RAI 03.07.02-29, Revision 1**QUESTION:**

RAI from Section 3.7 Audit, October 2010

REVISED RESPONSE:

Figure 03.07.02-29.60: Model of Cantilever Subjected to Harmonic Axial Force, Aspect Ratios 1:1, 2:1, 4:1, and 5:1 (Not to Scale)

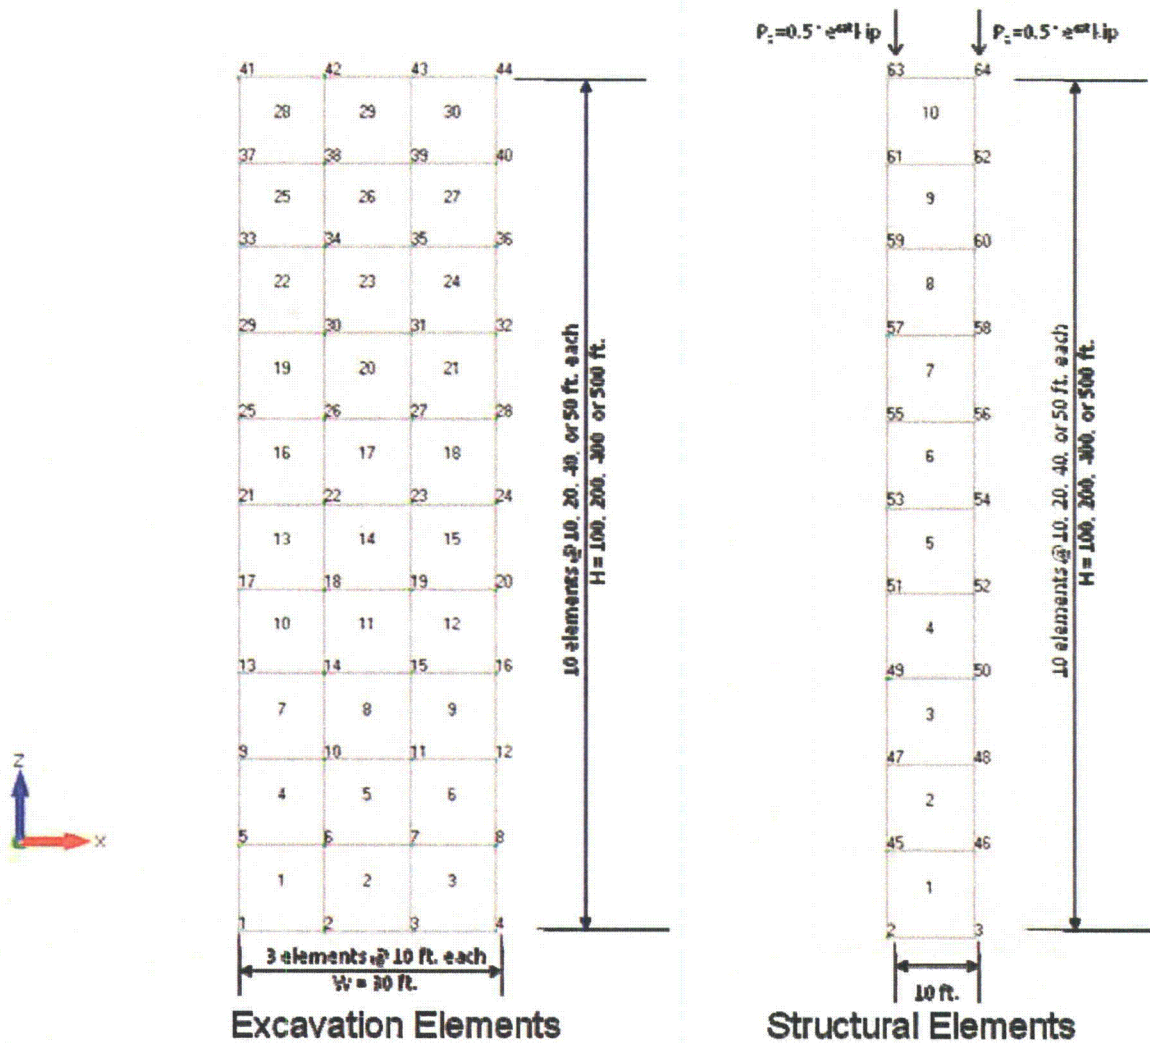
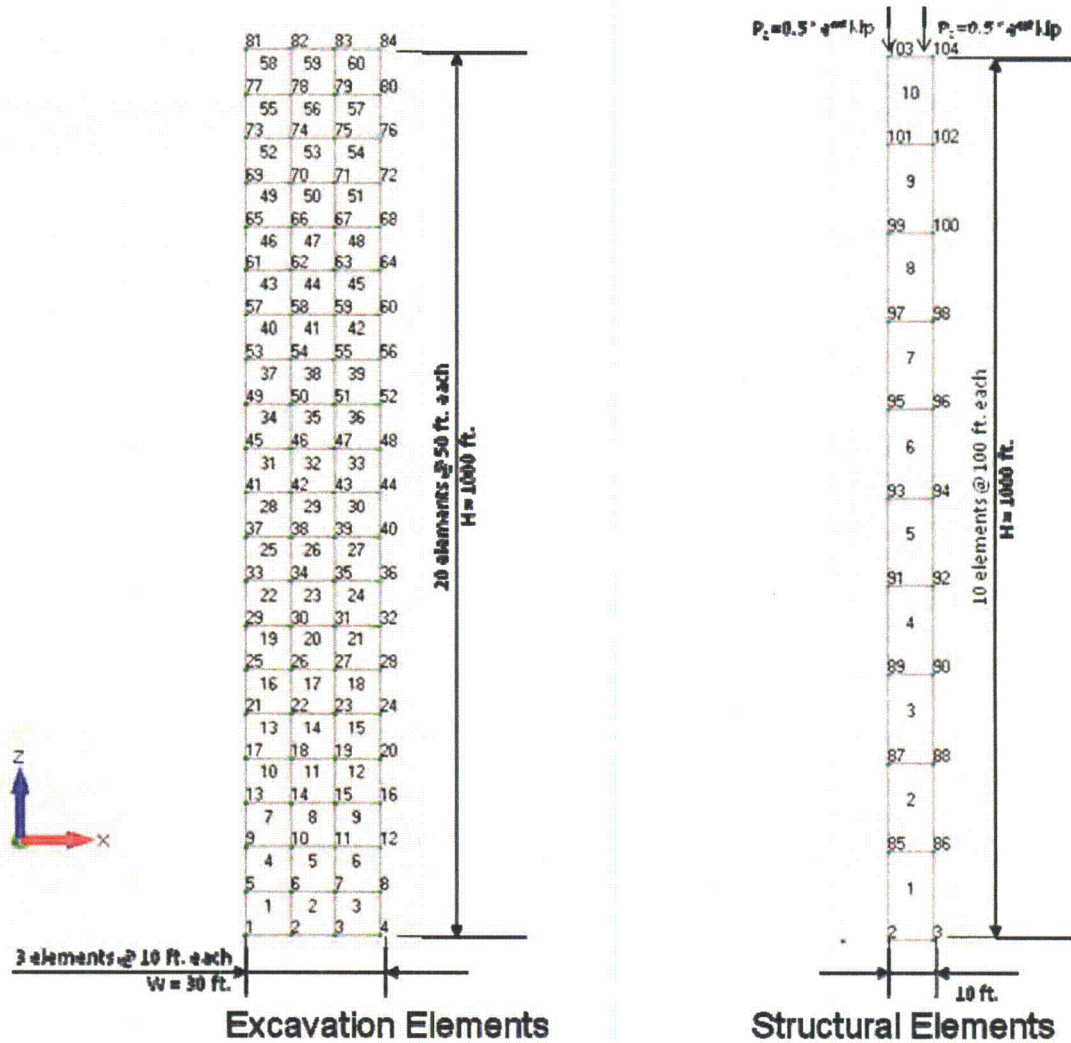
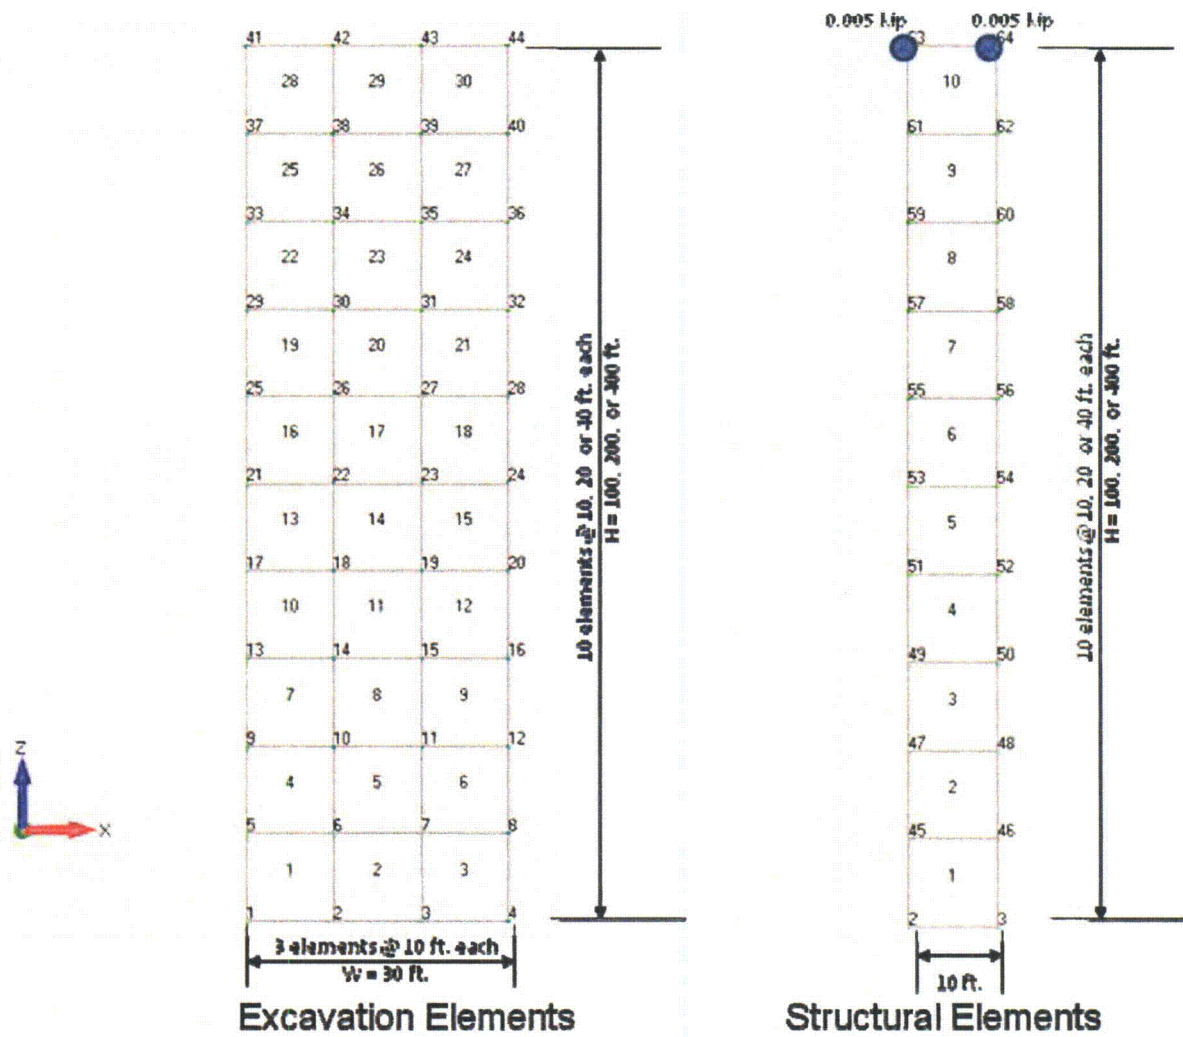
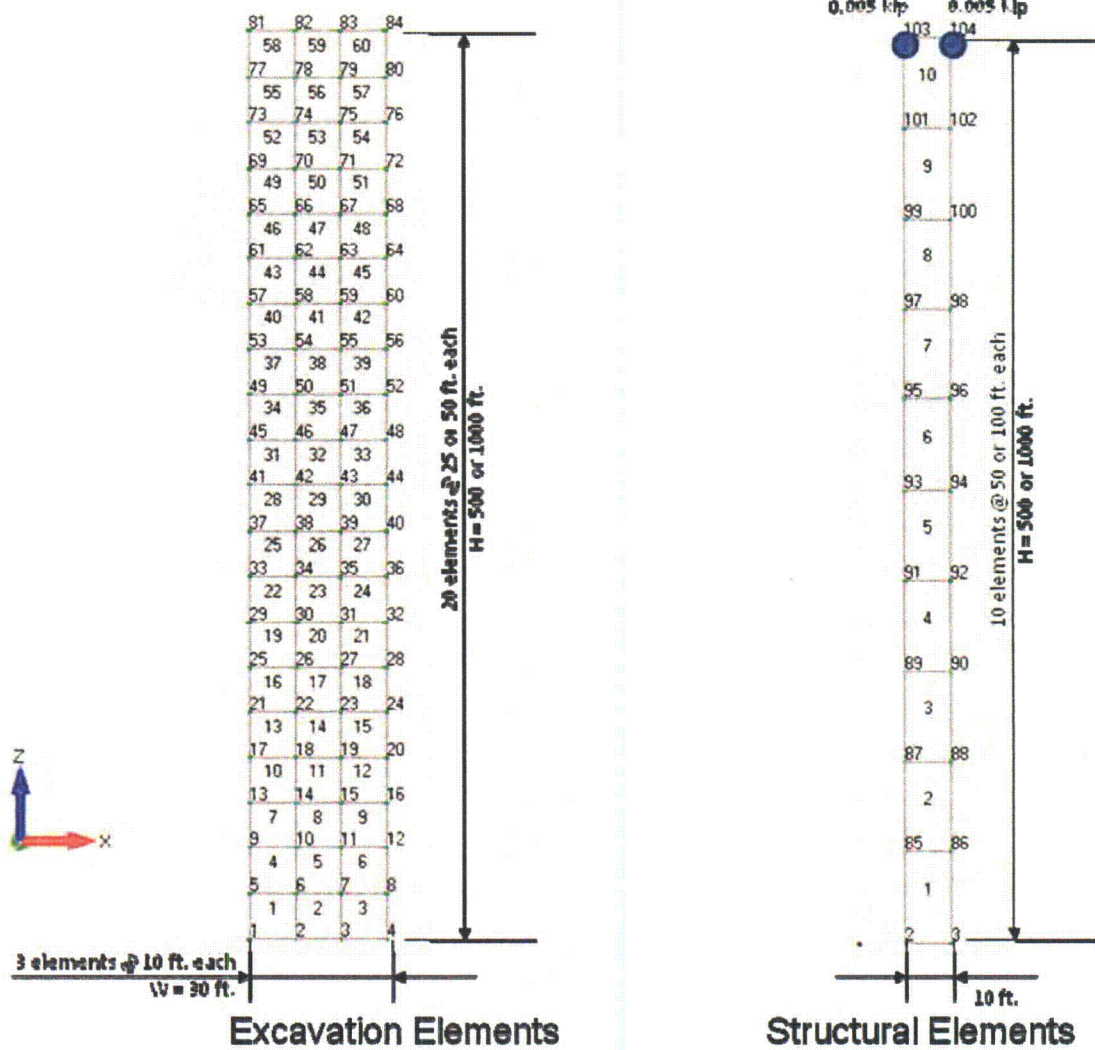
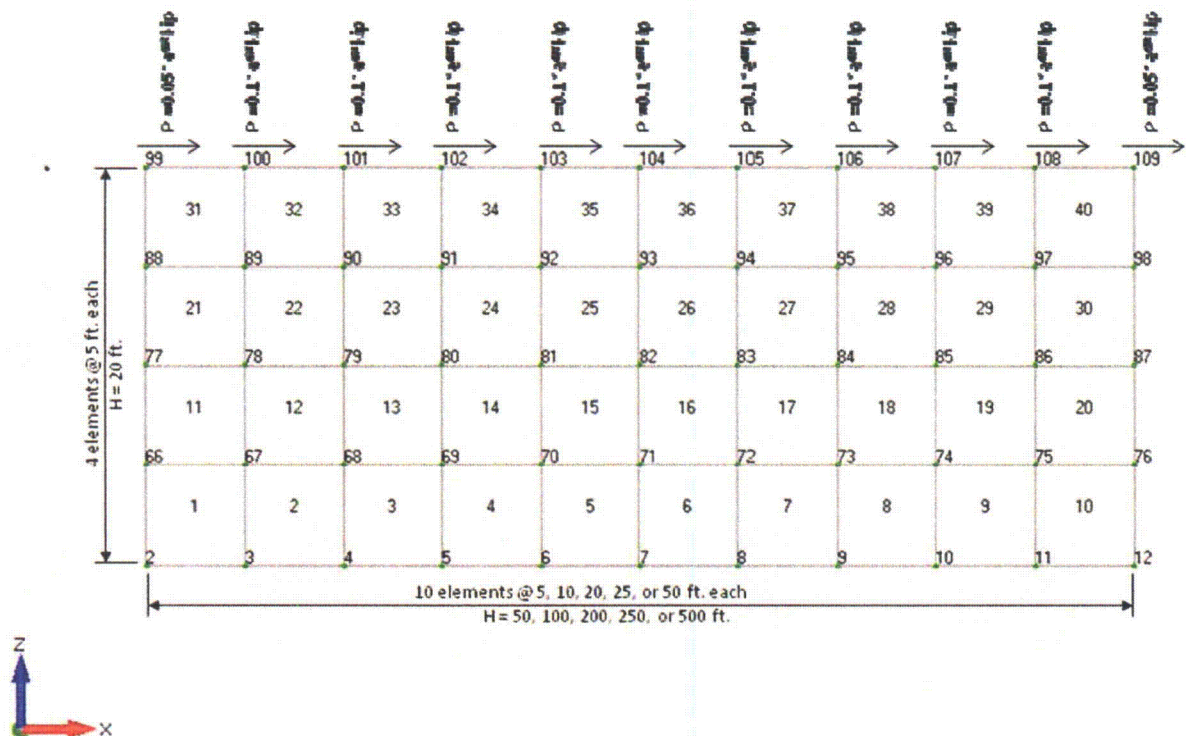
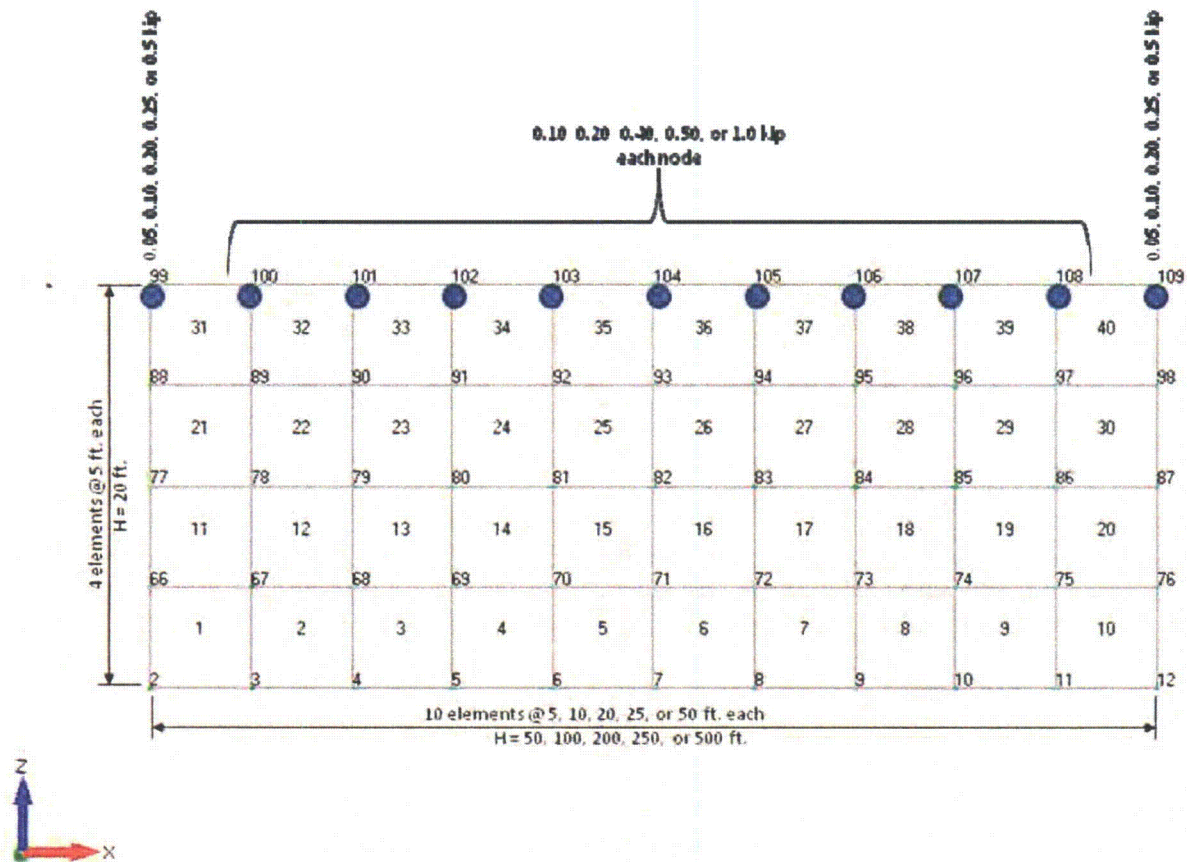
- **Acceptable aspect ratio of rectangular elements (solid, shell and plane-strain) to obtain accurate results, as used in the models**

Models similar to the validation of the thick shell elements (SGH) are used for validation of 2D plane strain elements. The models are excavated, and the 2D plane strain elements are placed within the excavation but not connected to the excavation sides, and the models are not loaded in the out-of-plane direction because out-of-plane motion is incompatible with 2D analyses. The models are shown in Figures 03.07.02-29.60 through 03.07.02-29.67.

Based on above results it is concluded that the 2-D plane strain elements can be used with aspect ratios up to 10:1.
